New Richmond Bridge and traffic improvements – Stage 1 The Driftway

Submissions report

Transport for NSW | March 2022

Figure 3.1 Property access adjustments

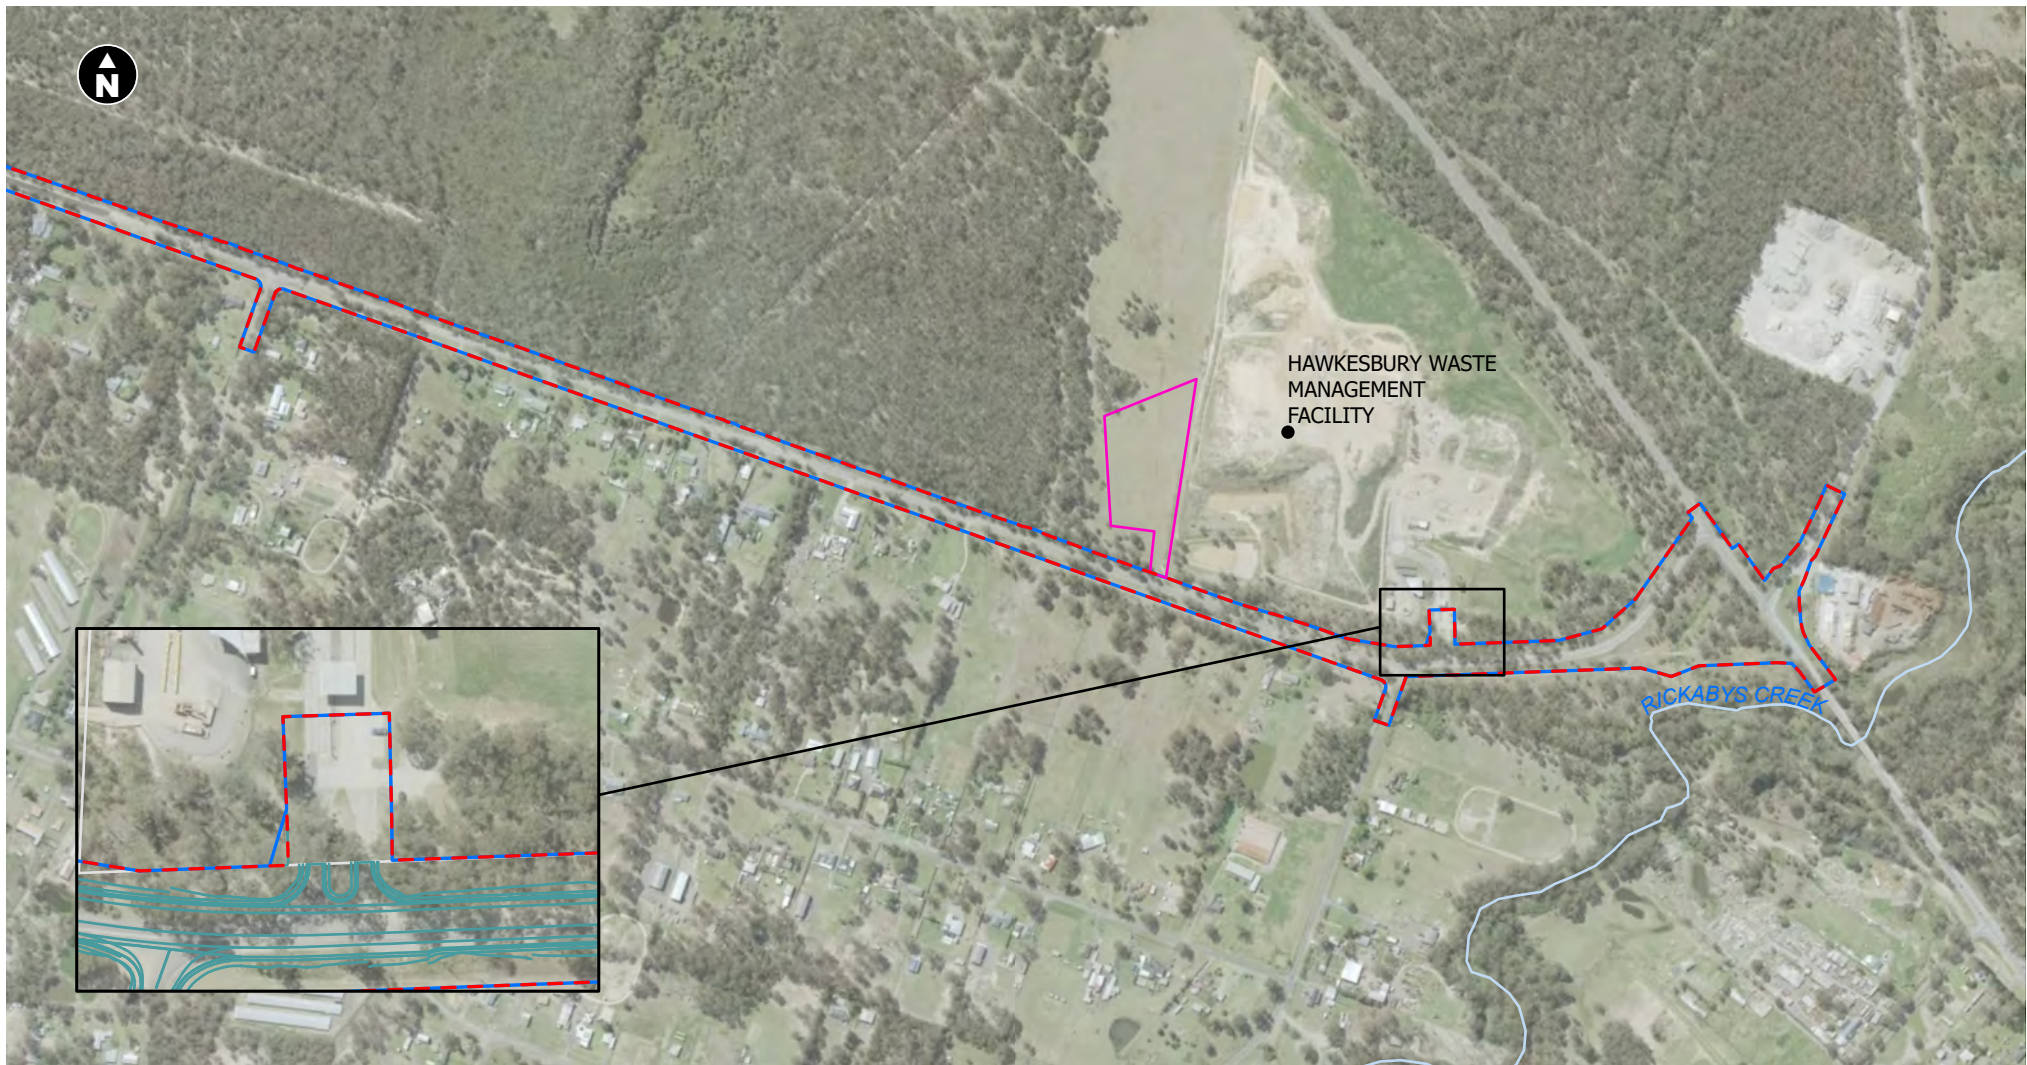
- The proposed driveway modifications would complicate access and egress for residents along The Driveway
- Forecasted increases in traffic and the reduction in the width between property boundaries and the road would result in road obstructions and safety issues for residents when entering and exiting their properties
- Would the road access from The Driftway into the Hawkesbury Waste Management Facility be upgraded to provide easier access and egress now and in future.

The property access of the Hawkesbury Waste Management Facility would be upgraded to provide a channelised right turn bay and widened to cater for the turning paths of a 26 metre B-Double in accordance with the *Austroads Guide to Road Design* (Austroads, 2009) and Transport for NSW supplements to the Austroads Guide standards.

To cater for the turning path of a 26 metre B-Double, a minor property adjustment to the fence would be required. The horizontal and vertical alignment of The Driftway at this location would also be modified to improve sight distance to the west. The modifications would improve safety and ease of access to the Hawkesbury Waste Management Facility and were not included in the design criteria provided in the REF. Changes to the proposal design are provided in Section 4.2.

- The existing pavement surface would be stabilised and strengthened by overlaying 210 millimetres of asphalt to achieve a 40-year design life, rather than a 20-year design life, as detailed in the REF
- Batters forming the drainage on the southern side of The Driftway are 6:1 on the road side with 2:1 on the property side. Where space permits and within the assessed proposal footprint, 2:1 batters would be revised in the design to 4:1 with localised steepening to avoid constraints
- Minor property access adjustments to five private properties, including four private residences located along the southern side of The Driftway and the Hawkesbury Waste Management Facility to accommodate revised road levels, drainage design and vehicle access. This will result in an additional 0.01 hectares to be included in the proposal footprint. The changes are highlighted in Figure 3.1.
